# AIA® Document G709™ – 2018

## Proposal Request

Textron West Campus  
C3 Brite Works

Proposal Request Number: 005

PAVEMENT AND SWS MH DETAILS

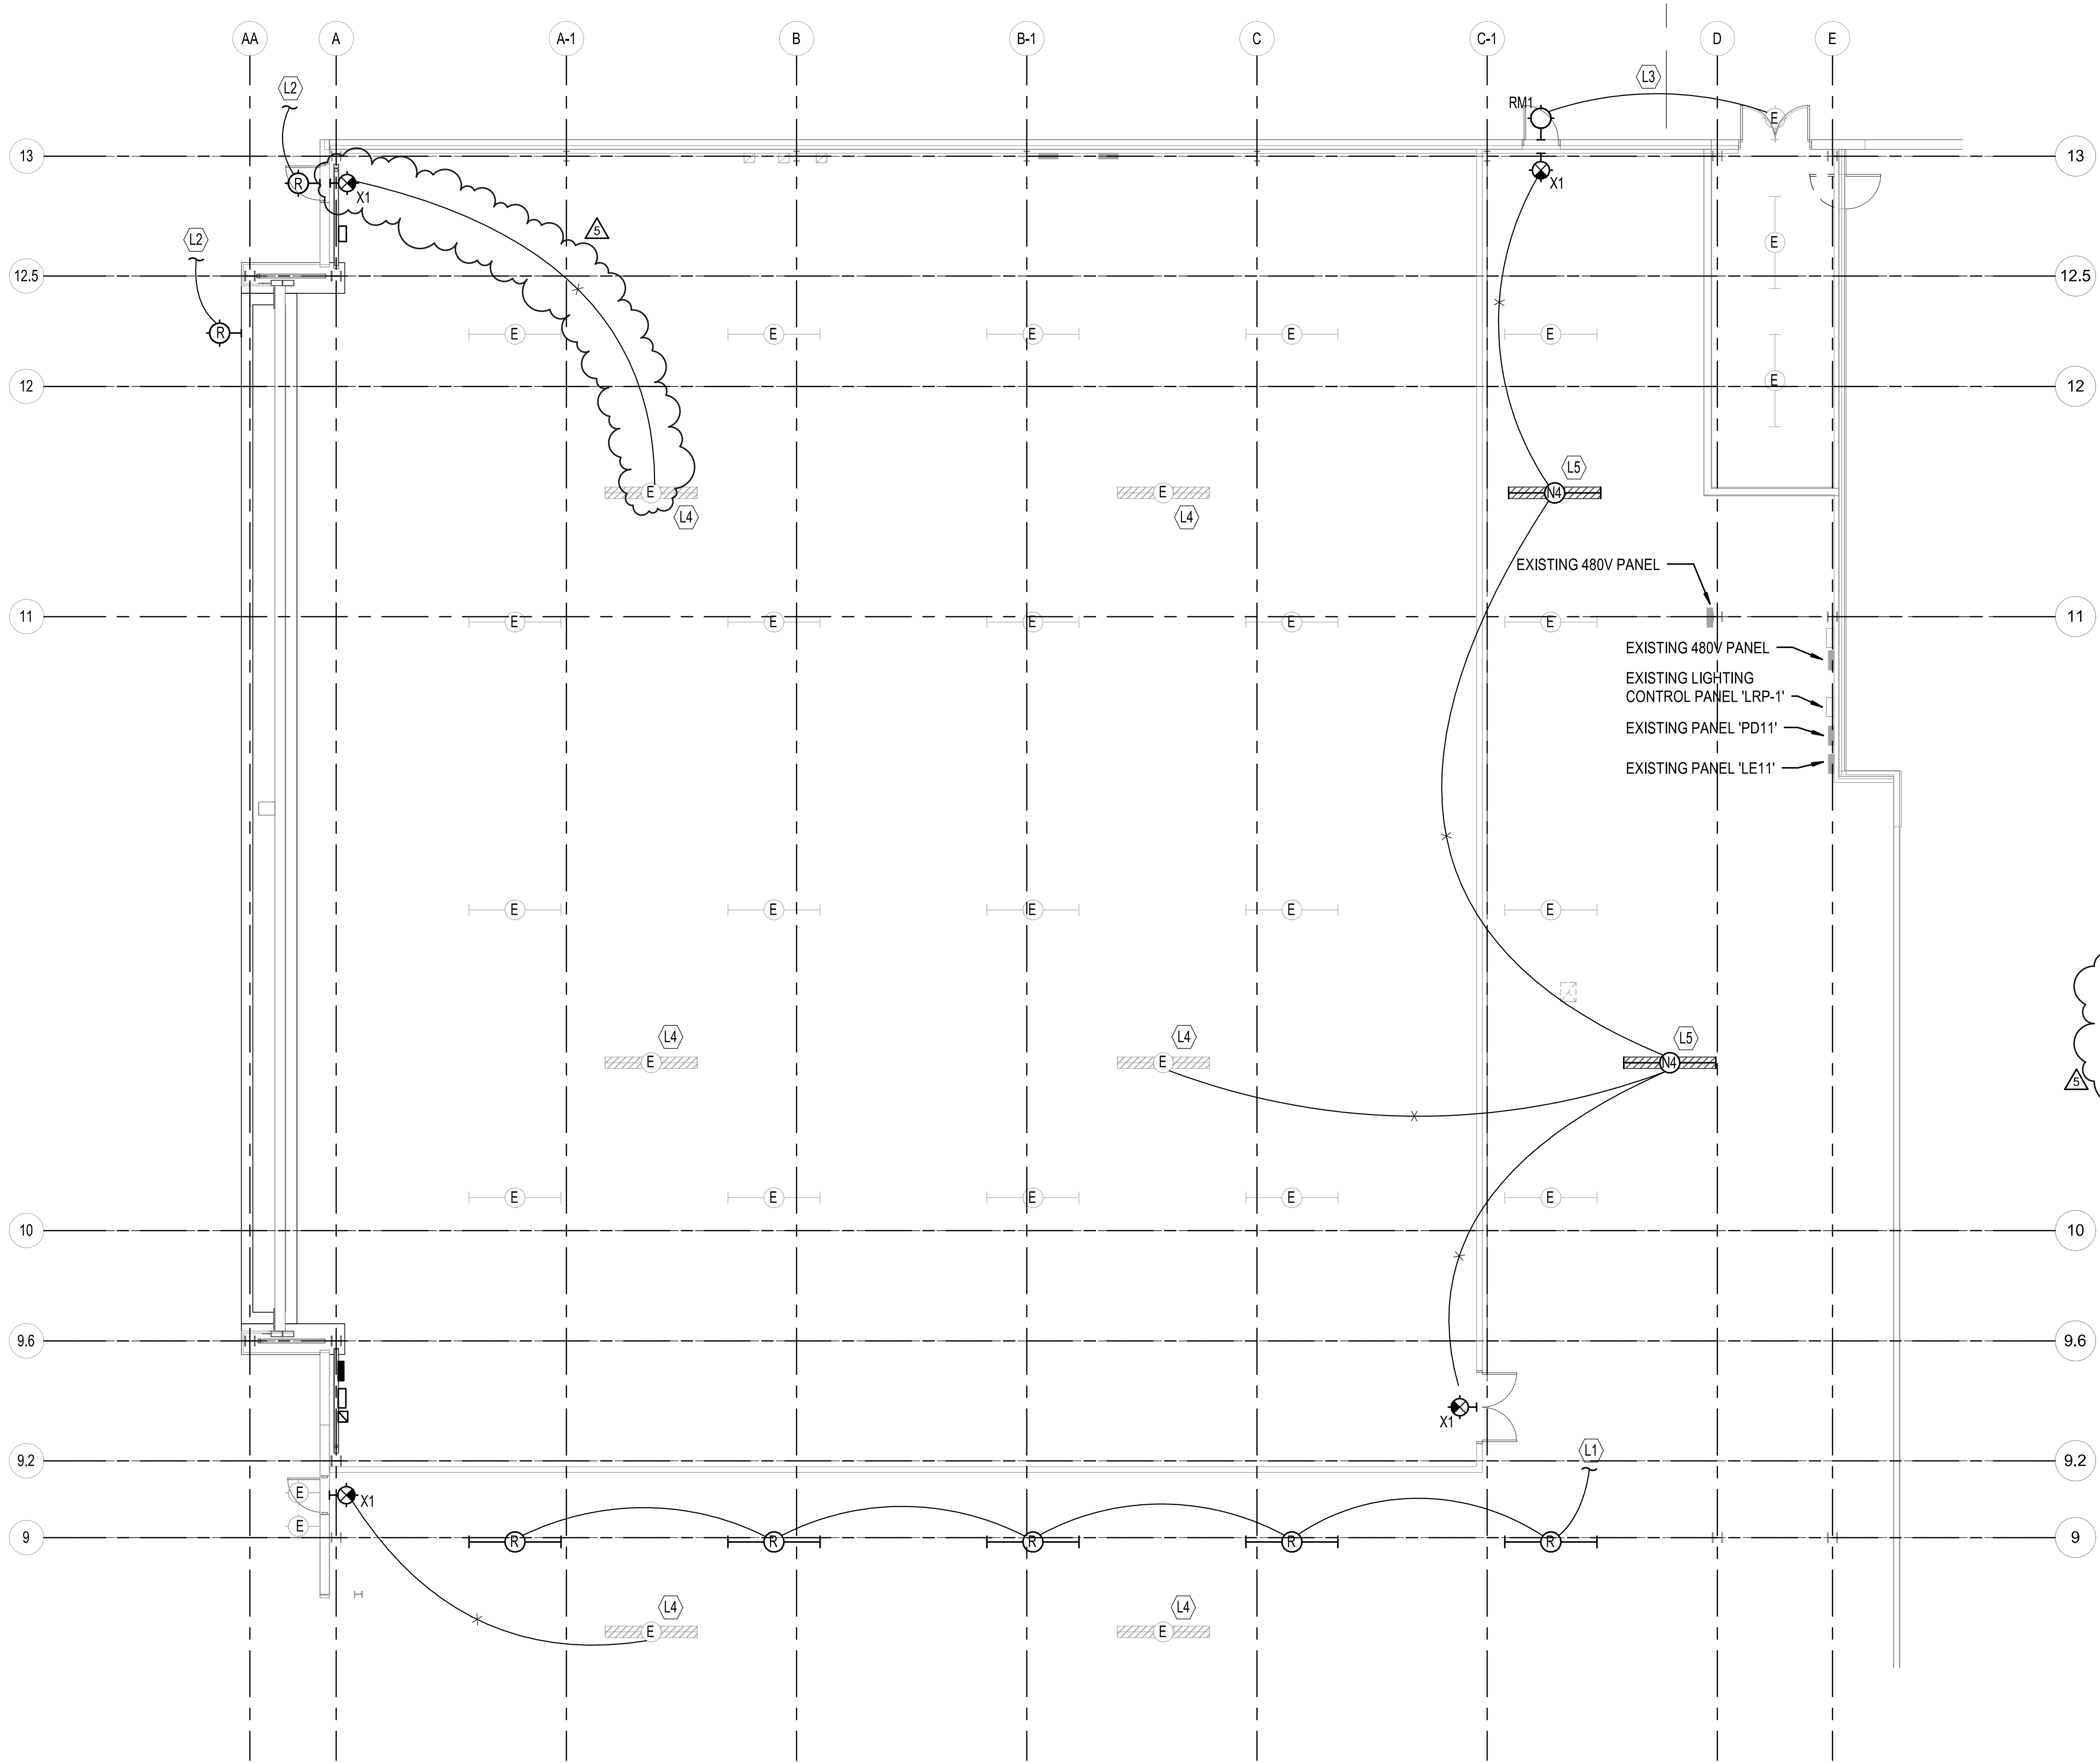
Sheet C-201, C-202, C-203, C-101, C-102, C-103, C-104: Updated for submittal of PPD.

**A ELECTRICAL LIGHTING FLOOR PLAN**  
 0" 8" 16" 24" 1/8" = 1'-0"  
 PLAN NORTH

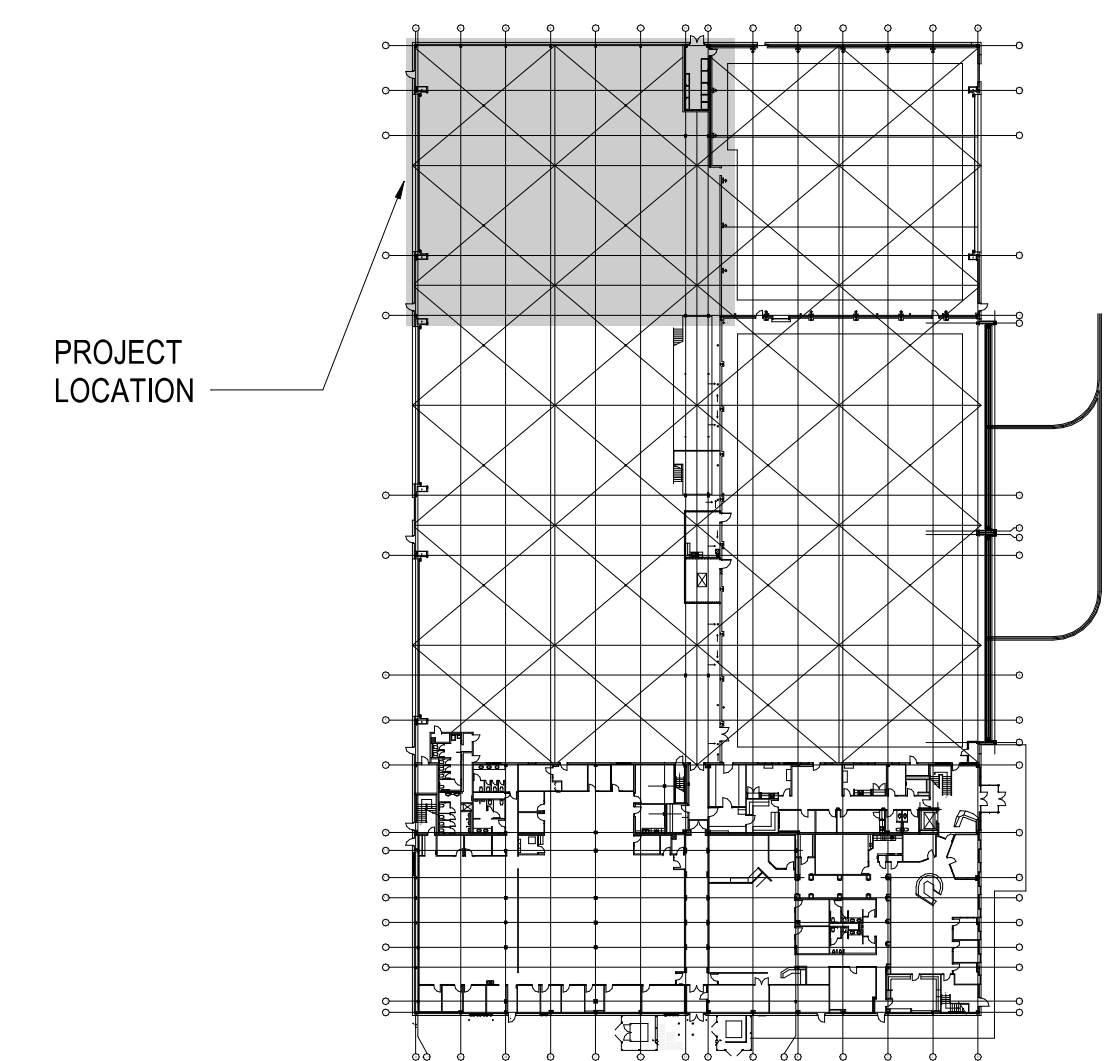
Sheet E-501: Updated to accommodate MABCD comments.
